SERVICE BULLETIN

Reference:	342-49-049 – SERVICE BULLETIN
Title:	Update of removal and installation procedures following the release of SB 342-49-048
Issue number:	001
Issue Date:	27-apr-2023

This Service Bulletin (SB) is applicable to all APU power plant fitted on Leonardo Helicopters AW189/AW149 helicopters.

Some procedures need to be updated with regard to the new combustor casing design, which modified the locking of the ignition and main manifolds' burners, igniter plugs and drain valve. The impacted procedures, updated in this Service Bulletin, are the following:

Figure 8: Burner manifold - Installation procedure

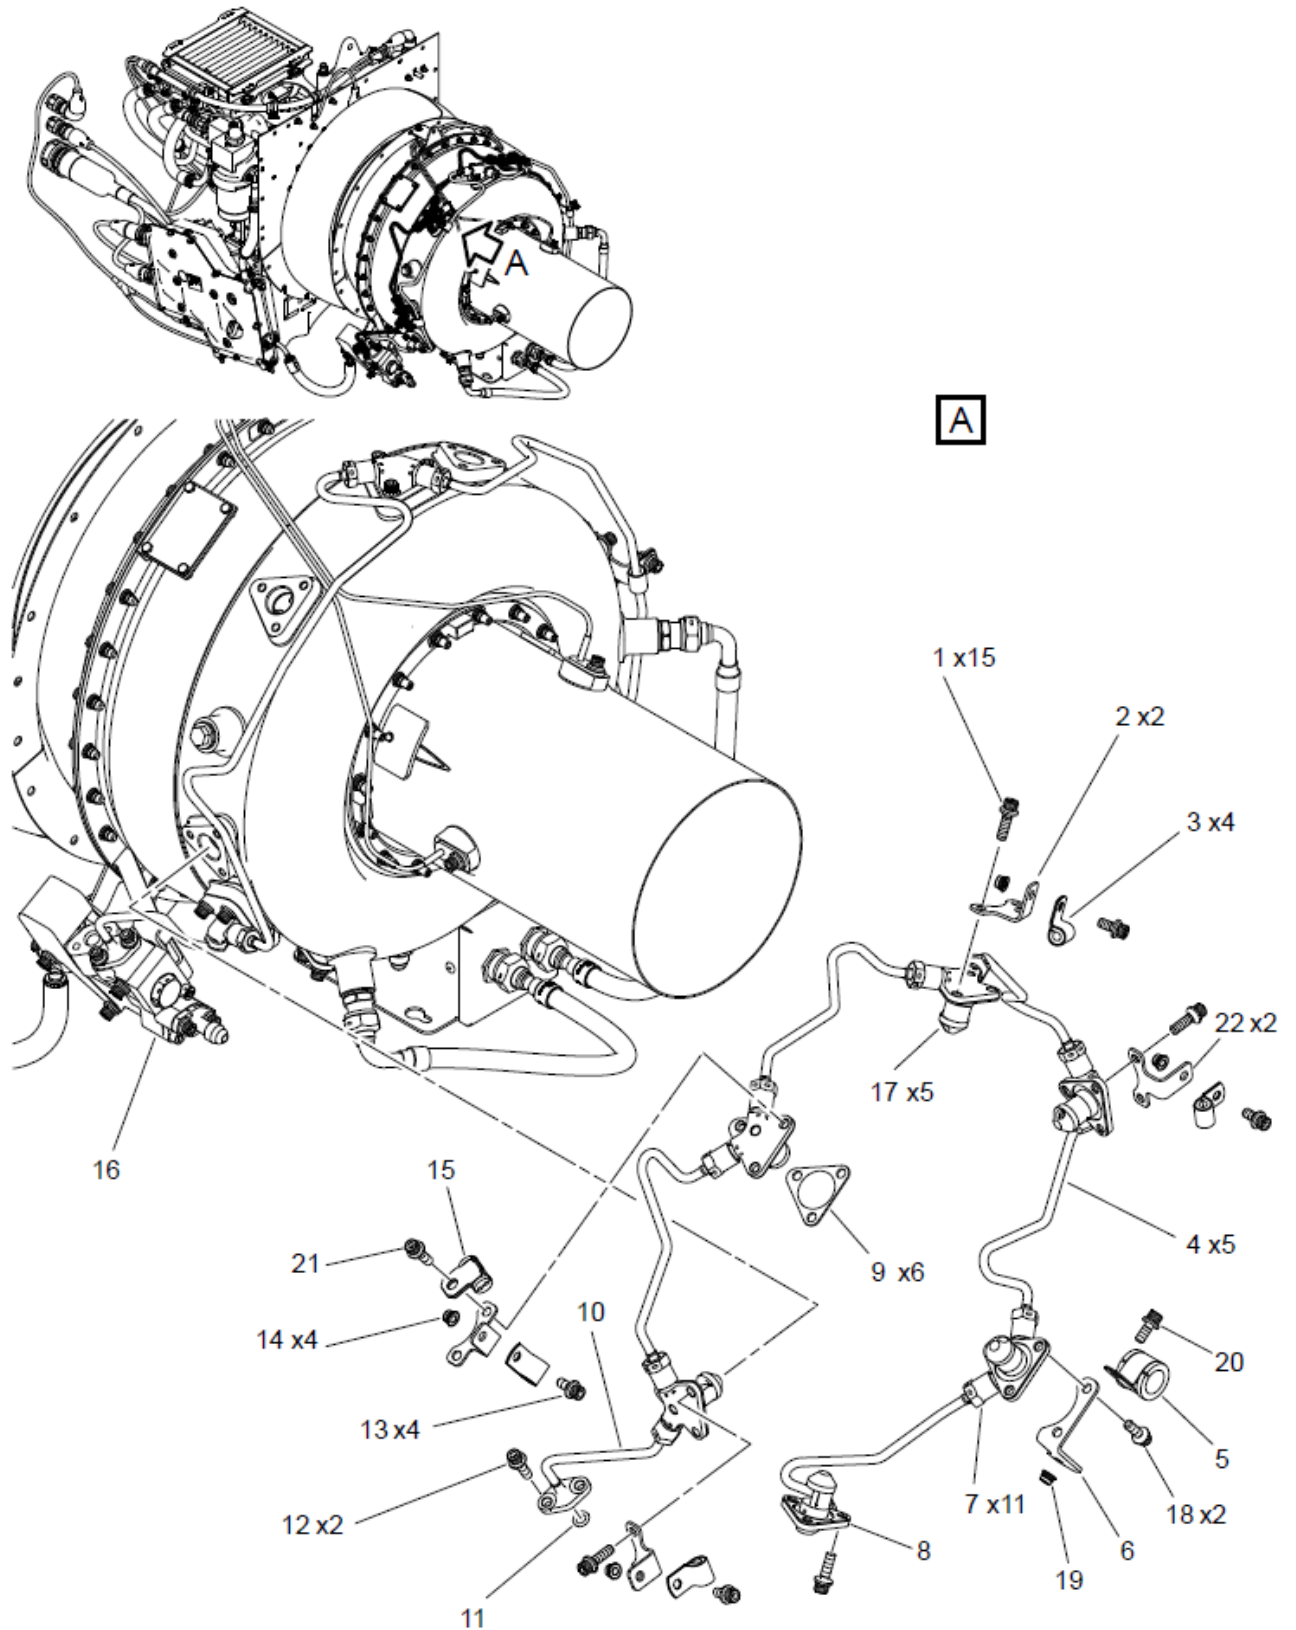
To make sure that the APU configuration is post-modification SB 342-49-048 configuration, manually run down a screw (2, Figure 8) and check that the head of the Screw (2, Figure 8) correctly seats on the combustor casing boss.

2. Remove the 12 protective plugs from the six burners (8, 17, Figure 8).
3. Lubricate the 15 new Screws (1), the new Screw (21) and the two new Screw (18) with Graphited grease.

29. Installation of the main burners if the APU is a post-modification SB 342-49-048 configuration:

29.1 Make sure that the tightening torque of the 15 Screws (1), the Screw (21) and the two Screw (18) is 3,8 Nm (33,633 lbf.in) with a standard torque wrench.

Figure 10: Locking of the 15 Screws (1), the Screw (21) and the two Screw (18) (post-modification SB 342-49-048 configuration)

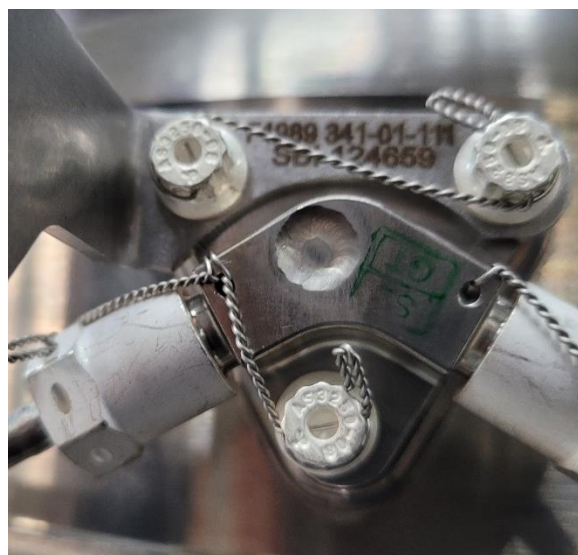
31. Installation of the main burners if the APU is a post-modification SB 342-49-048 configuration:

31.1 Lock the 15 Screws (1), the Screw (21) and the two Screw (18) with Lockwire as shown in the Figure 10.

Figure 12: Drain valve - Removal procedure

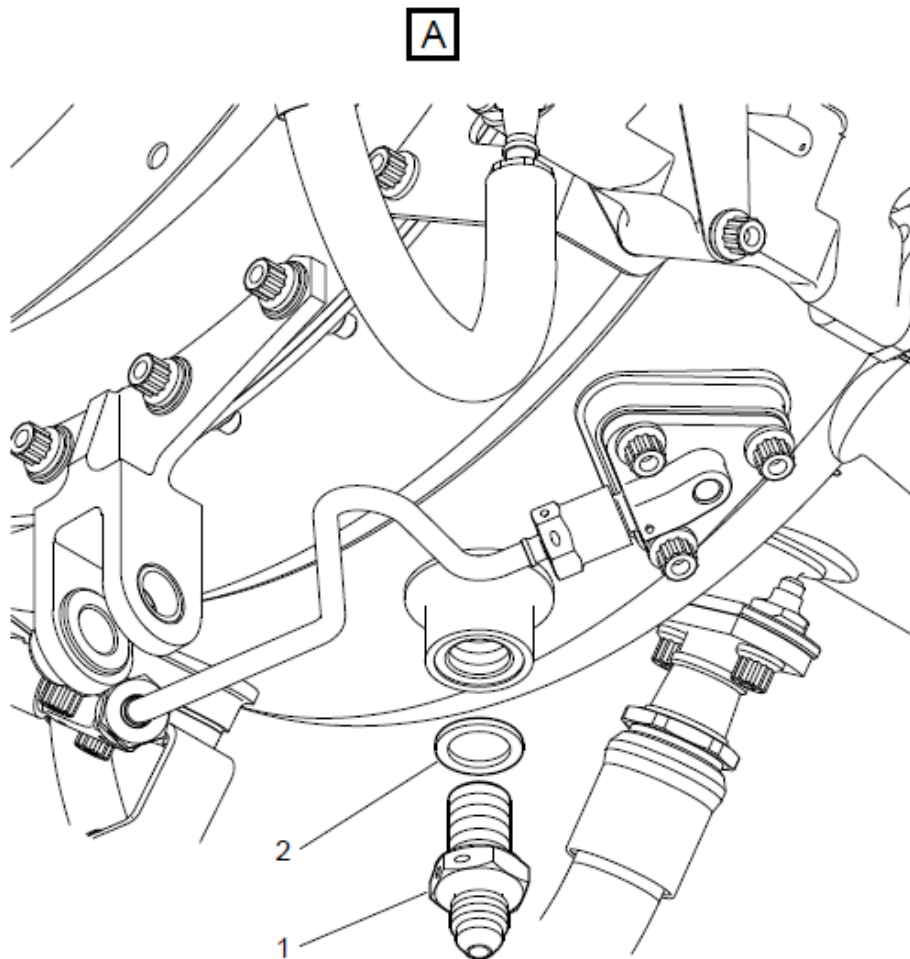
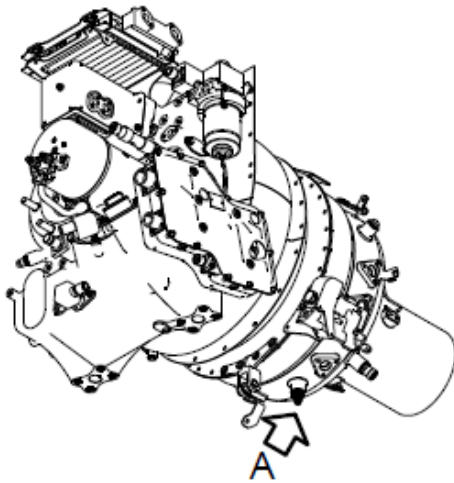
1. Removal of the drain valve if the APU is a post-modification SB 342-49-048 configuration:

Cut and remove the safety wire from the drain valve (1, Figure 12).

2. Remove the drain valve (1).
3. Remove and discard the gasket (2).
4. Install the Protective cap on the gas generator.

Figure 13: Drain Valve - Installation procedure

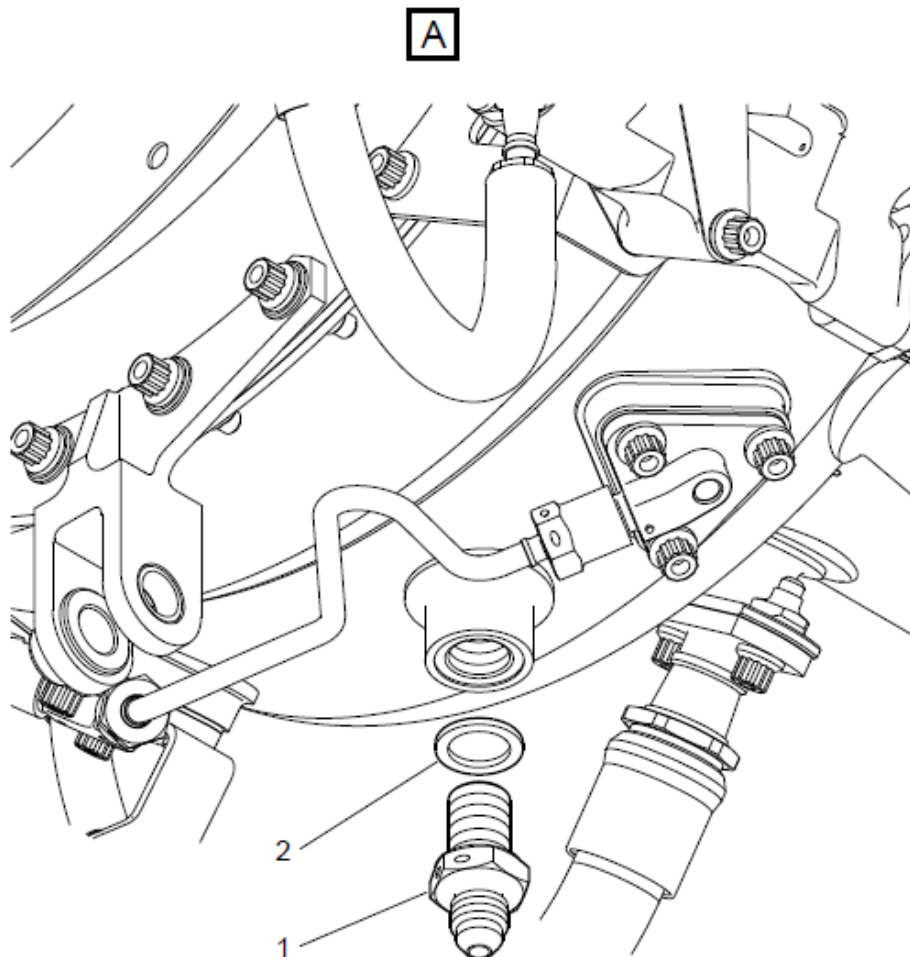
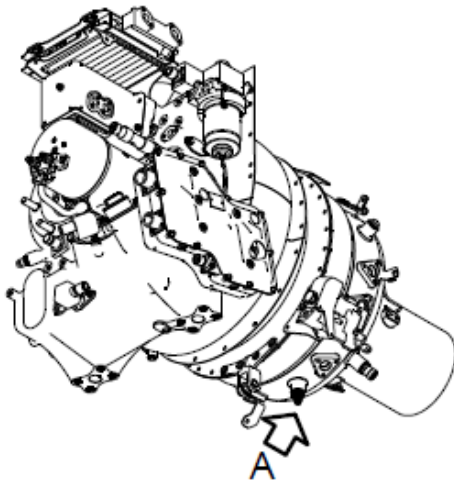
1. Remove the protective plug from the Drain valve (1, Figure 13).
2. Install the new Gasket (2) on the Drain valve (1).
3. Remove the protective cap from the gas generator.
4. Lightly lubricate the thread of the Drain valve (1) with Graphited grease.
5. Install the Drain valve (1).

6. Installation of the drain valve if the APU is a pre-modification SB 342-49-048 configuration:
 - 6.1 Torque the Drain valve (1) to 15 Nm (132.761 lbf.in).
7. Installation of the drain valve if the APU is a post-modification SB 342-49-048 configuration:
 - 7.1 Torque the Drain valve (1) to 8 Nm (70,806 lbf.in).
8. Install the Protective plug on the Drain valve.
9. Installation of the drain valve if the APU is a post-modification SB 342-49-048 configuration:
 - 9.1 If the APU is a post-modification SB 342-49-048 configuration, lock the nut of the drain valve (1) with Lockwire.

Figure 14: Temperature Probe T4-1 - Removal procedure (sheet 1 of 2)

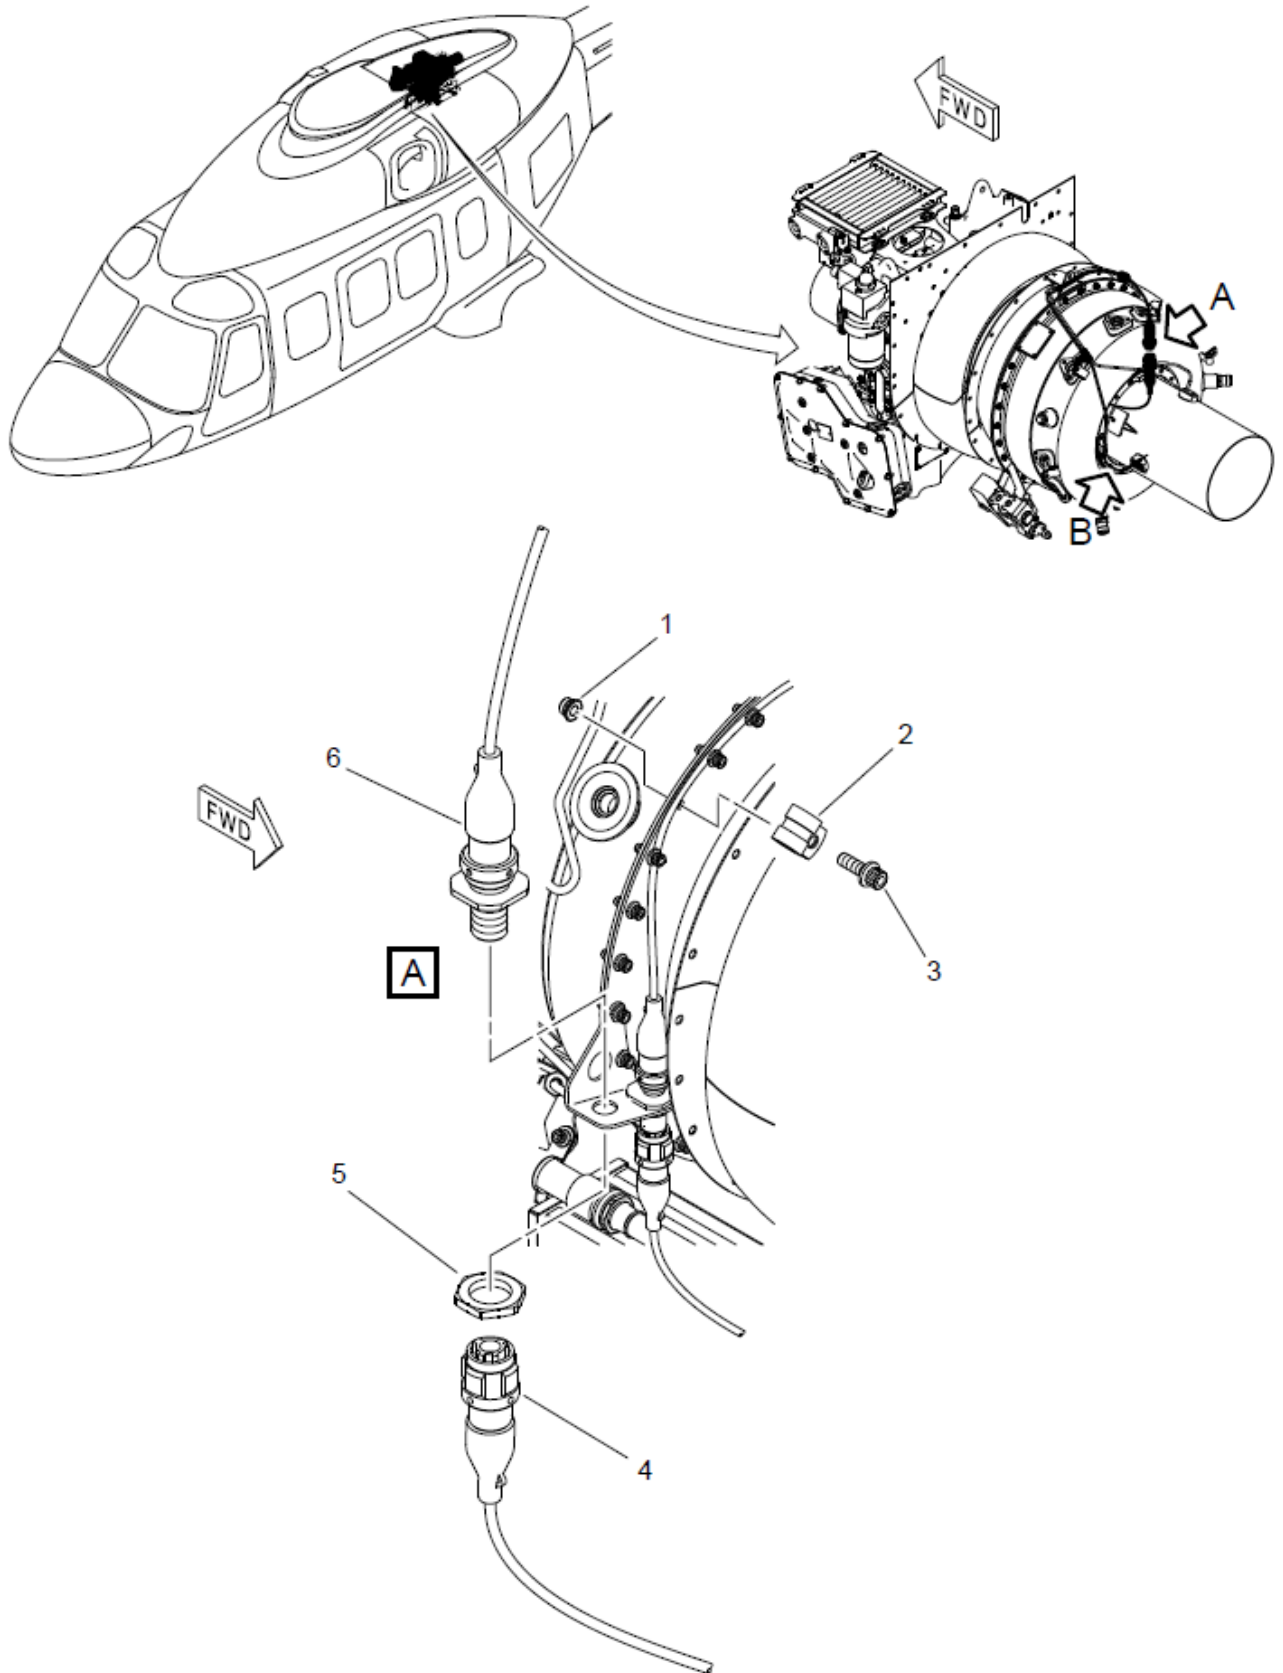
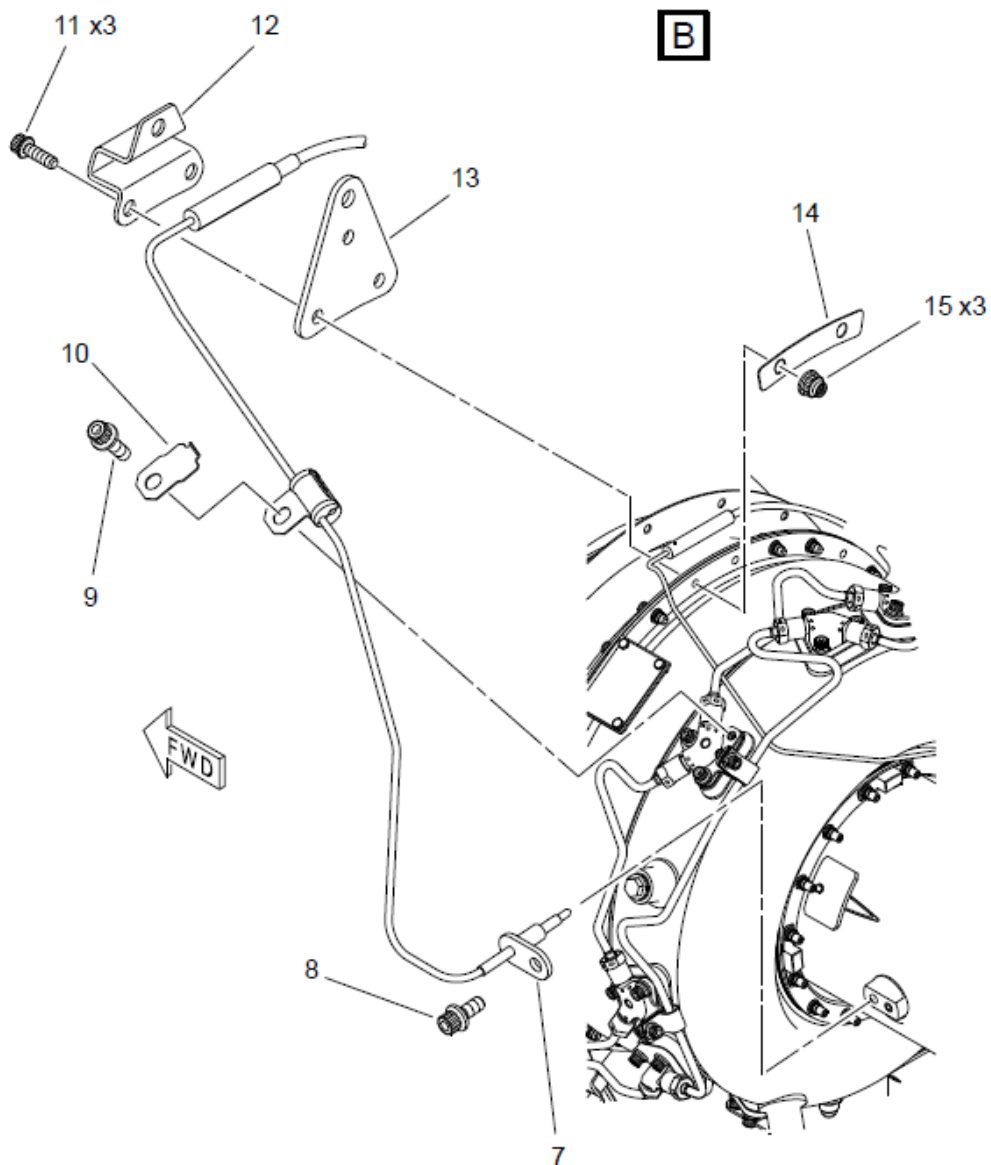
11. Removal of the temperature probe T4-1 if the APU is a post-modification SB 342-49-048 configuration:

Cut and remove the safety wire from the screw (9).

12. Remove and discard the screw (9) of the clamp (10).

13. Remove the clamp (10).

14. Remove and discard the screw (8) of the temperature probe T4-1 (7).
